UNITED STATES
NUCLEAR REGULATORY COMMISSION
REGION III
799 ROOSEVELT ROAD
GLEN ELLYN, ILLINOIS 60137

Reports No. 50-329/82-07(DETP); 50-330/82-07(DETP)

Facility Name: Midland Plant, Units 1 and 2

REPORT ON CABLE INSTALLATION
MIDLAND PLANT UNITS 1 AND 2

SK-12

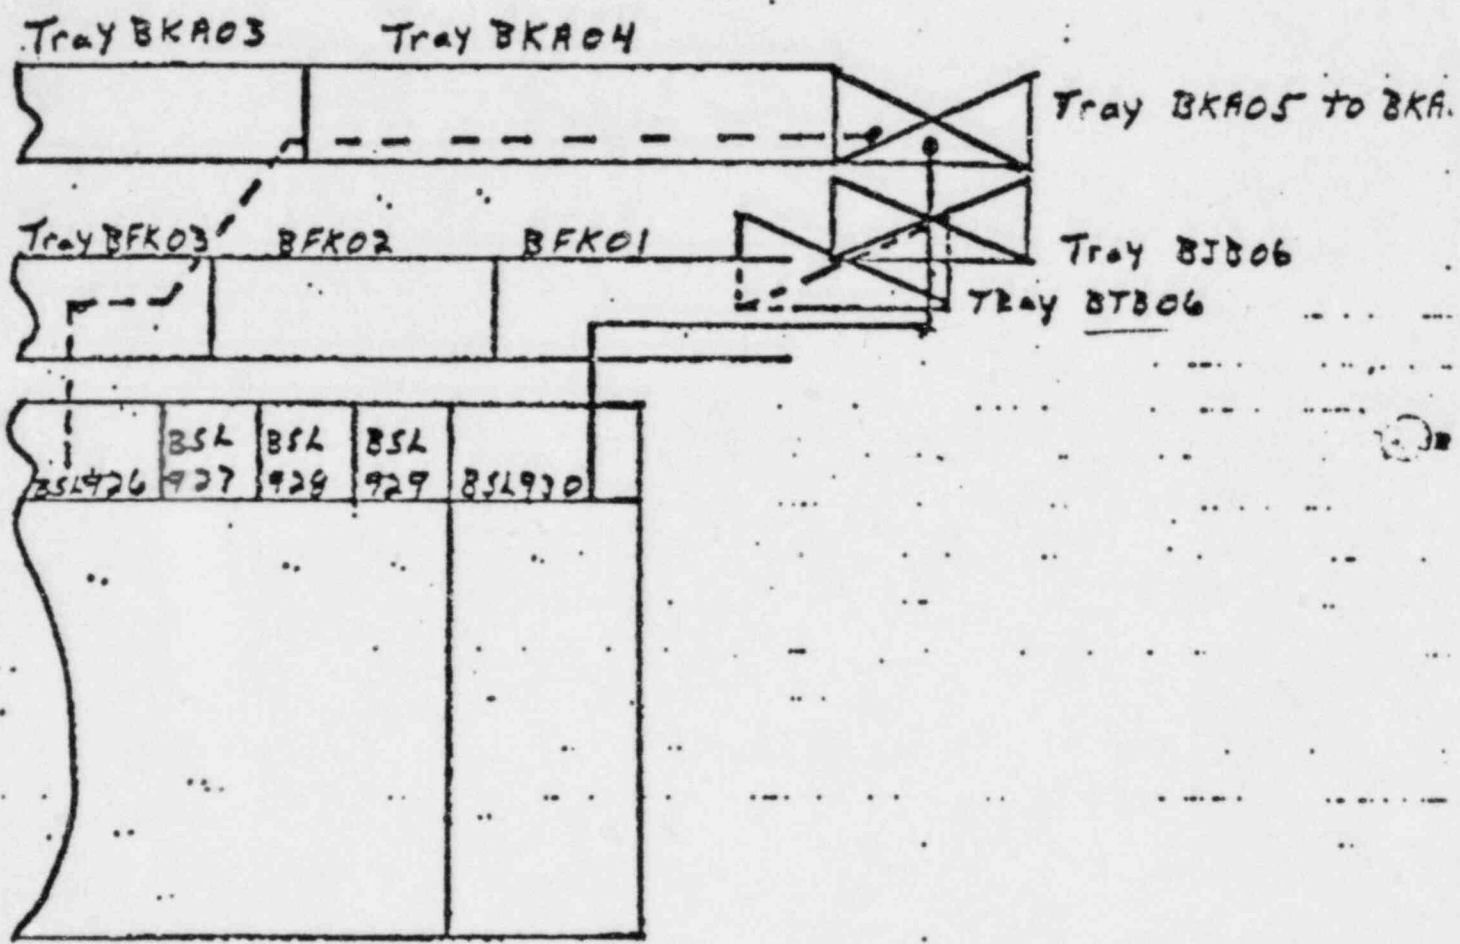
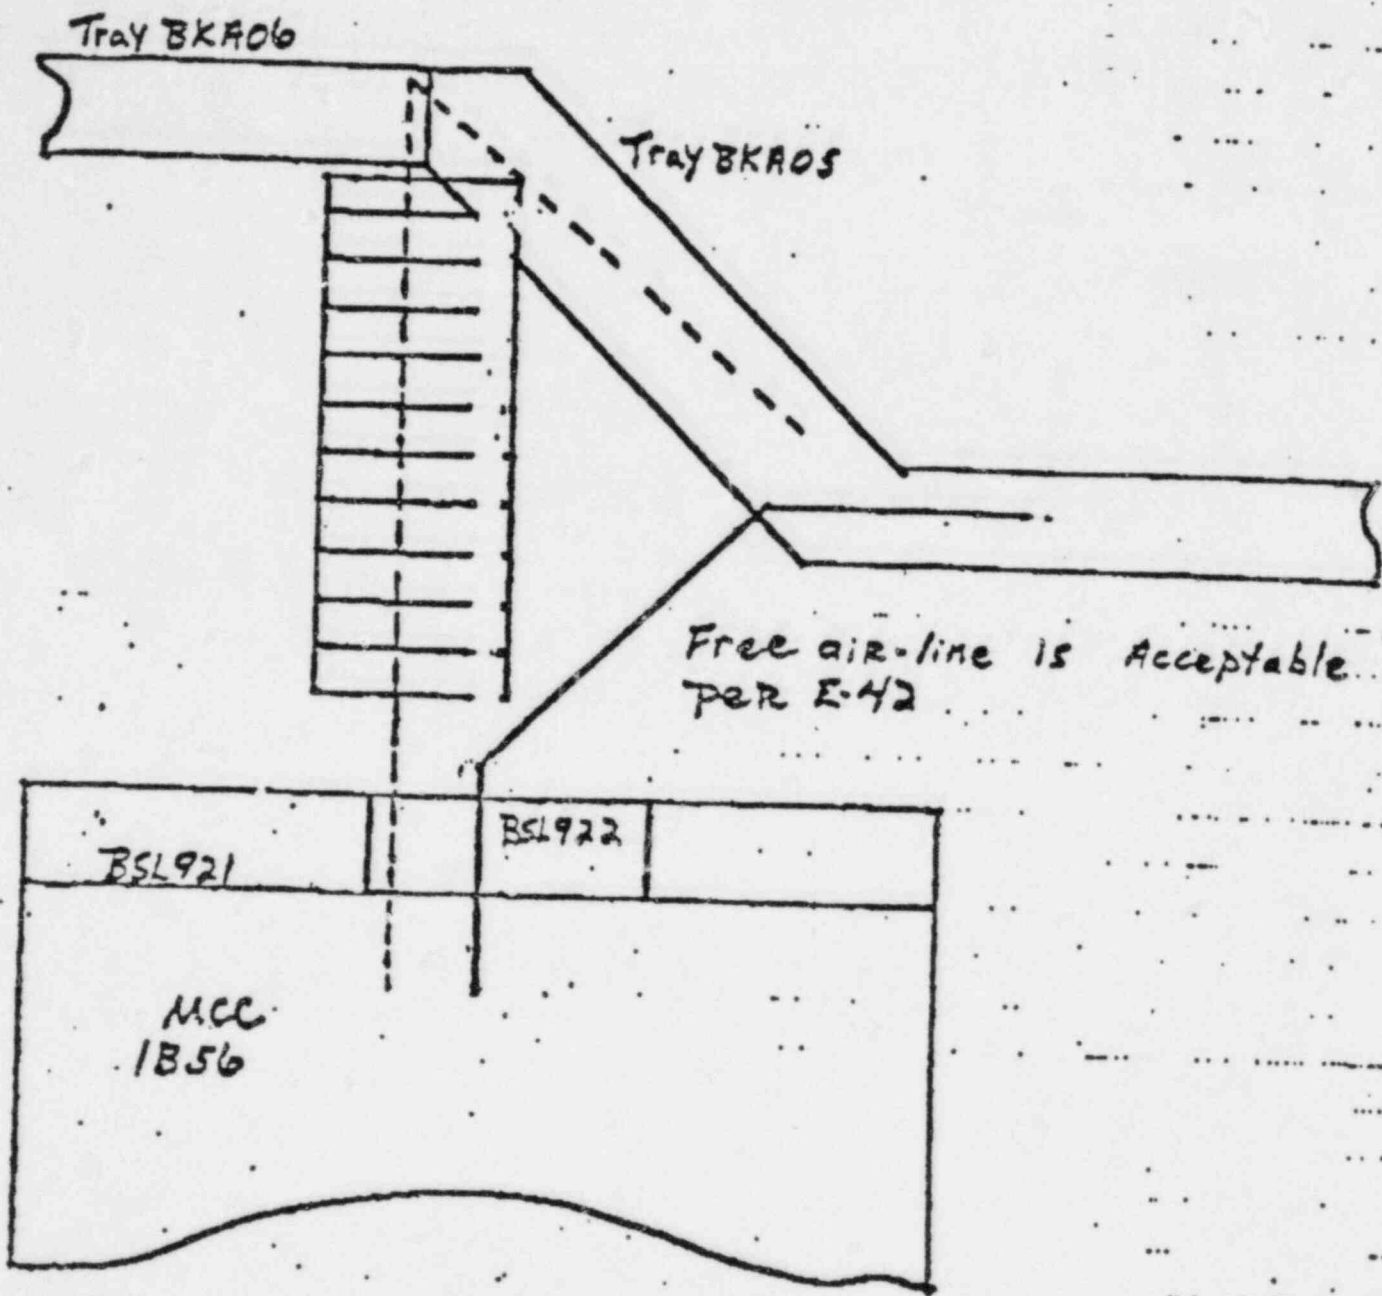
Cable was not installed as routed in E37 and a voltage violation was created when a power cable was run in an instrumentation tray.

SK-14

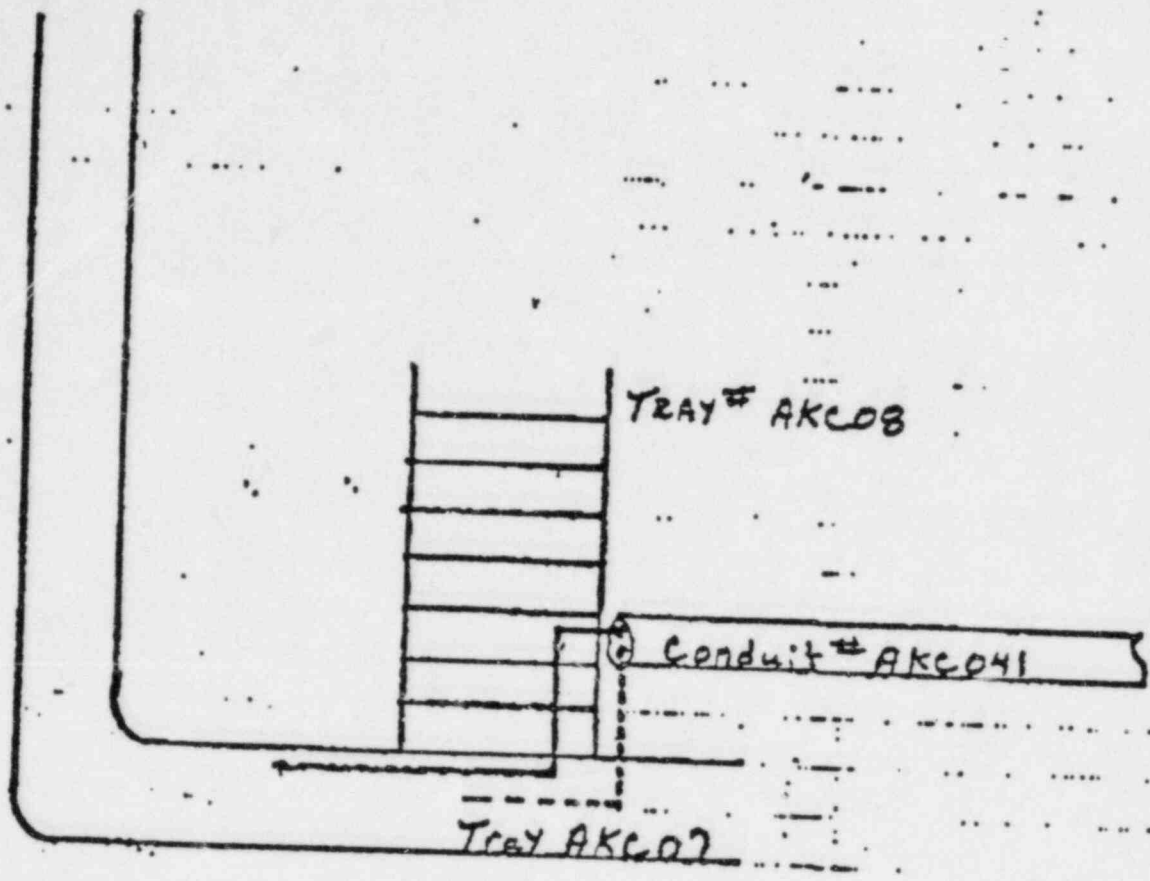
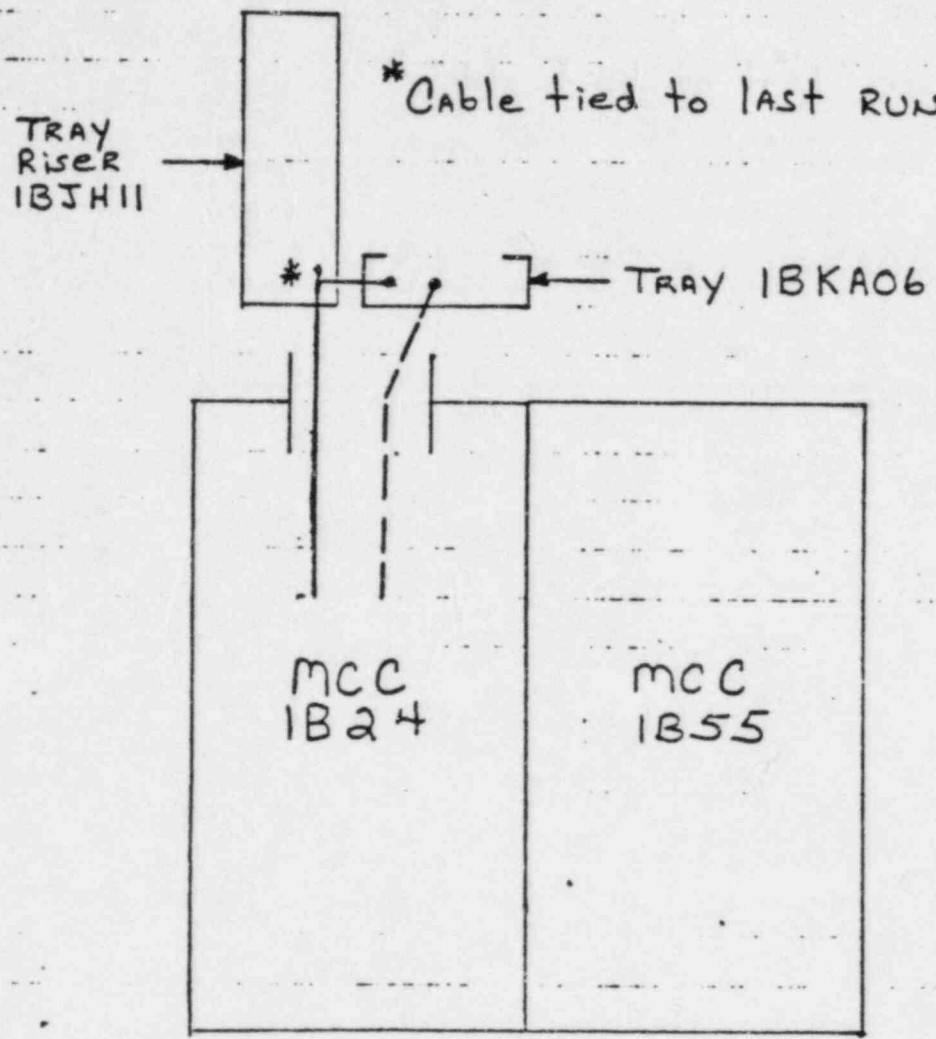
The subject cable enters the confines of additional raceway. If the trays containing the subject cable were required to be wrapped, how do we make sure that the cable portion in the unlisted via is protected.

SK#15
Midland Plant Units 1 and 2
Attachment³ to
Report on Cable Installation

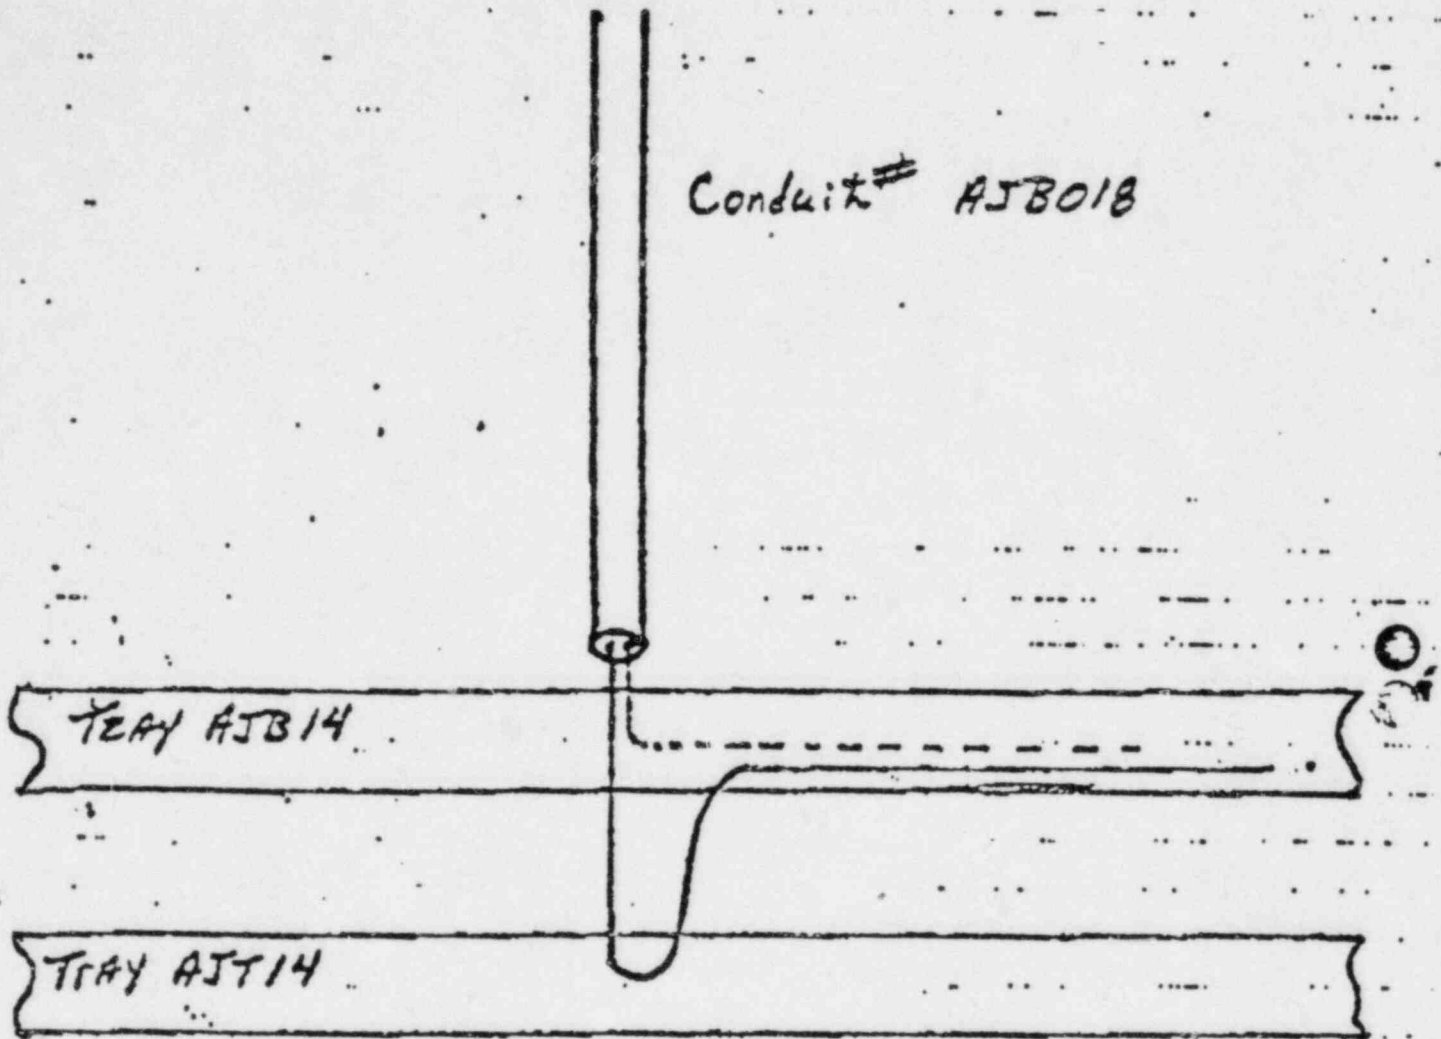
Cable is pulled into BJH11 which was not one of its assigned
vias.

The cable is only tied to the last rung of the riser, and will
not contribute to thermal loading of the riser.

SK-16

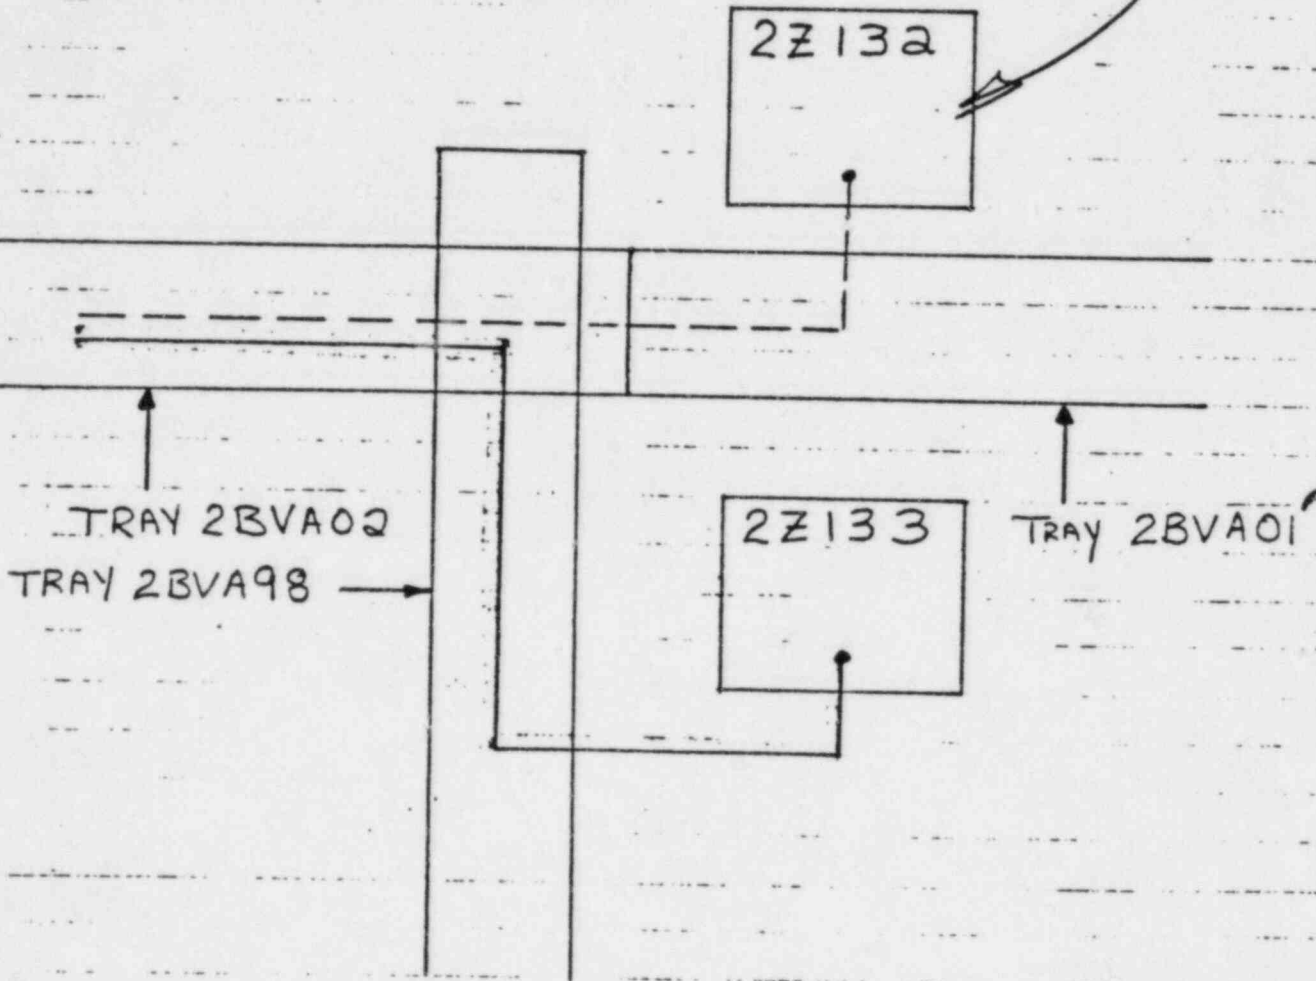
Cables looped out the bottom of tray AJB14 into tray AJT14.

SK 18

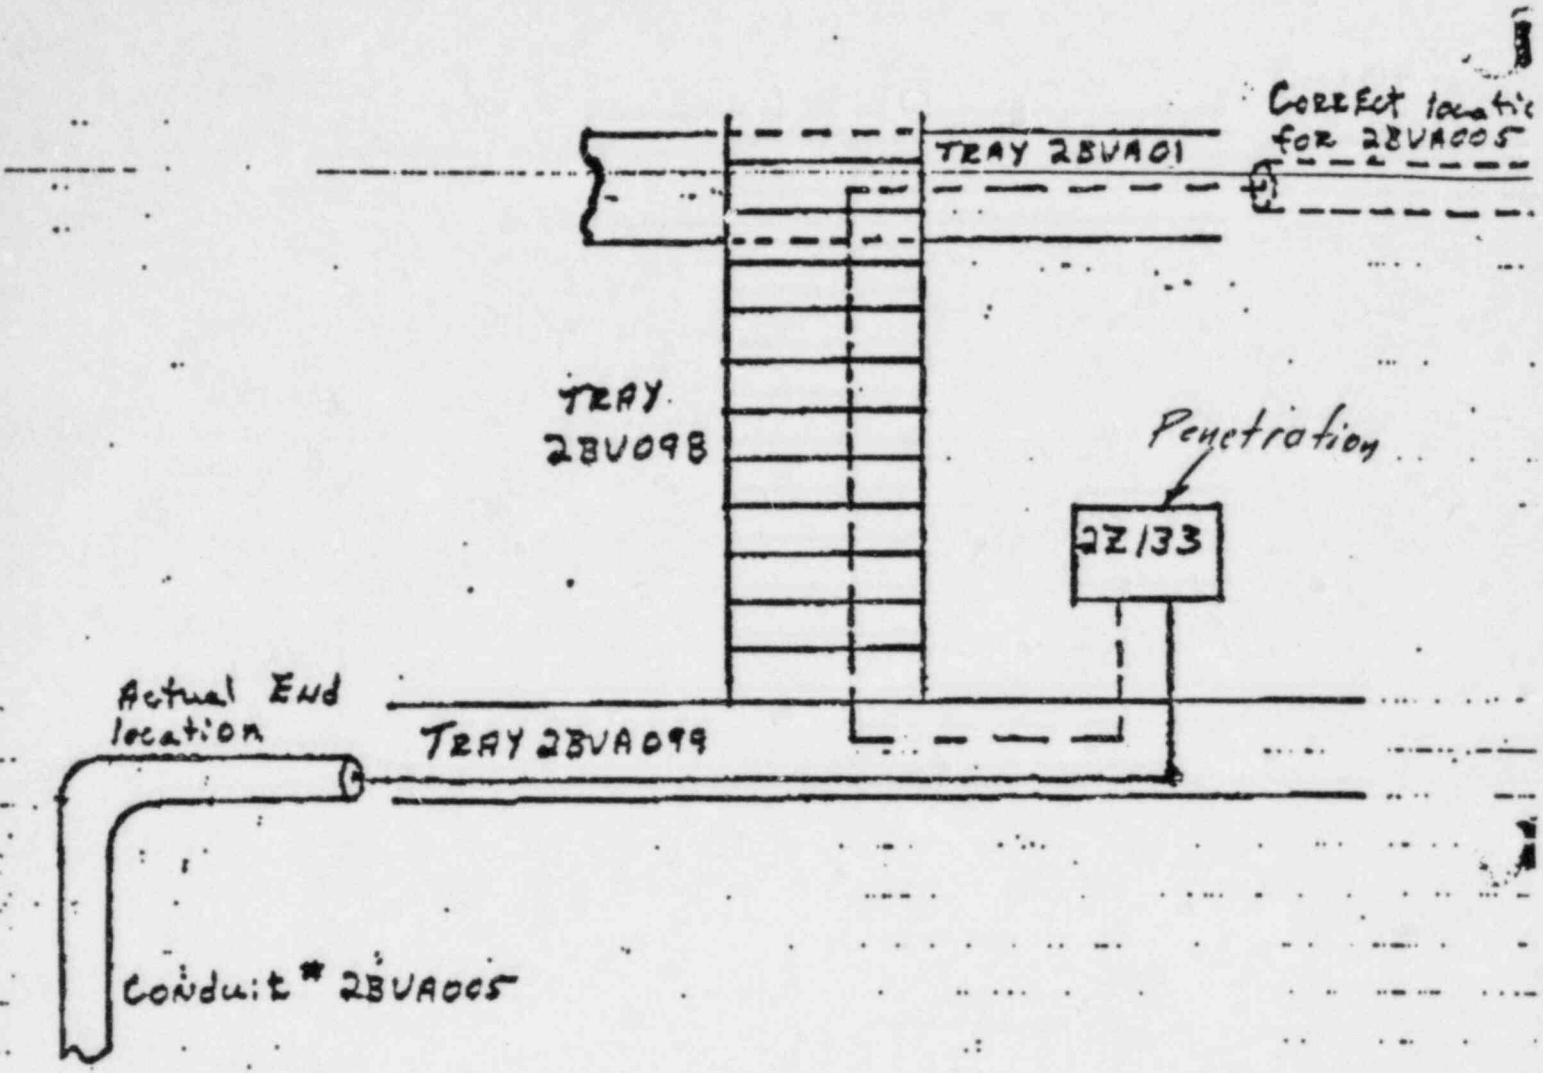
CONDUIT # 2BVA005 installed at incorrect. End locat
 should run to 2BVA01 ± 18" into adjoining TRAY section

The subject conduit installation had not been inspected by quality control. On discovering the incorrect conduit installation, cable misinstallation would have been corrected.

SK. 19
Midland Plant, Units 1 and 2
Attachment 3 to
Report on Cable Installation

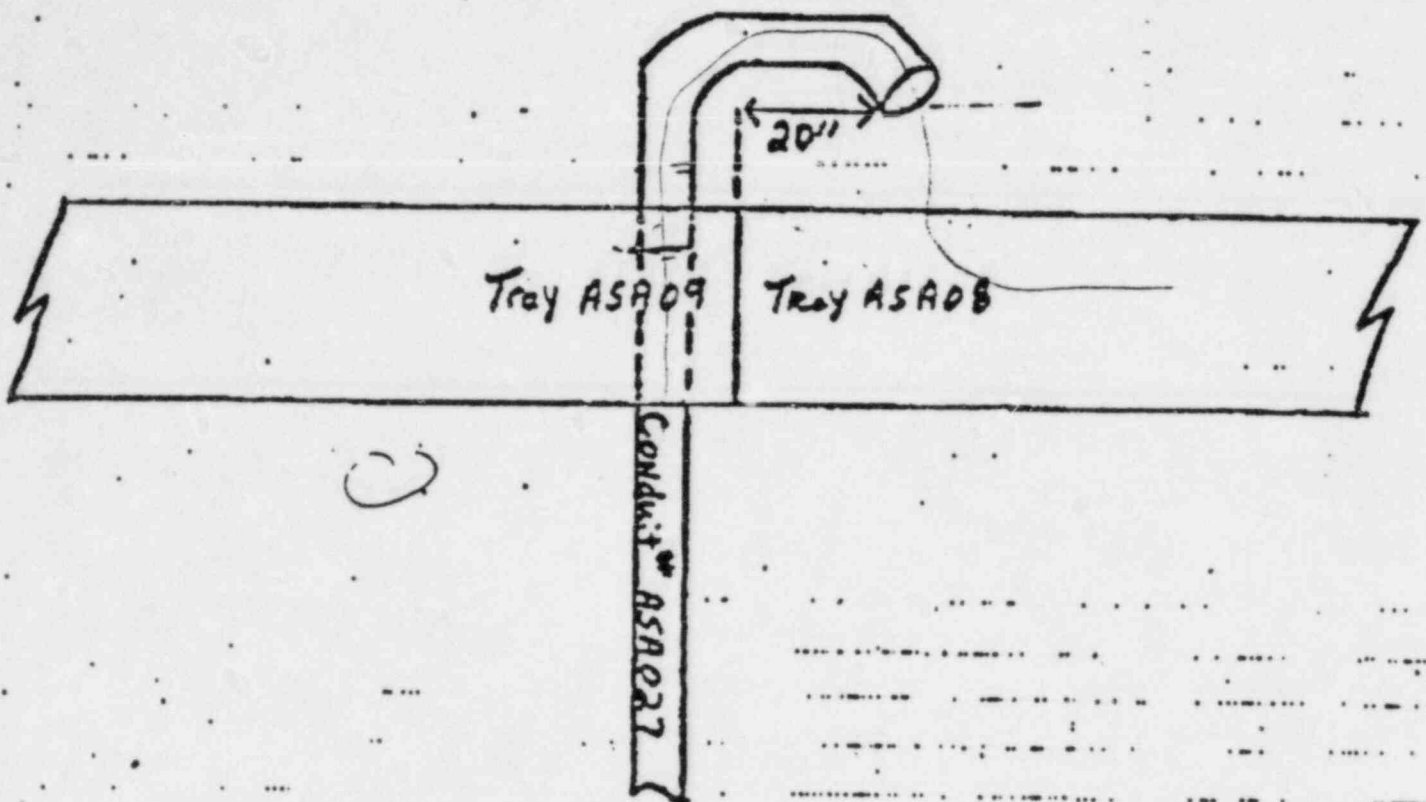
CONDUIT # ASA027 installed at incorrect END location.
Should run to ASA09 ± 18" into adjoining tray section.
Cable Vias per R-37 are: ASA027 ASA09 ASA08
Due to incorrect END location: ASA027 — ASA08

The actual cable installation did not use all the designed raceway vias. Therefore, the absence of a cable would only make thermal analysis more conservative.
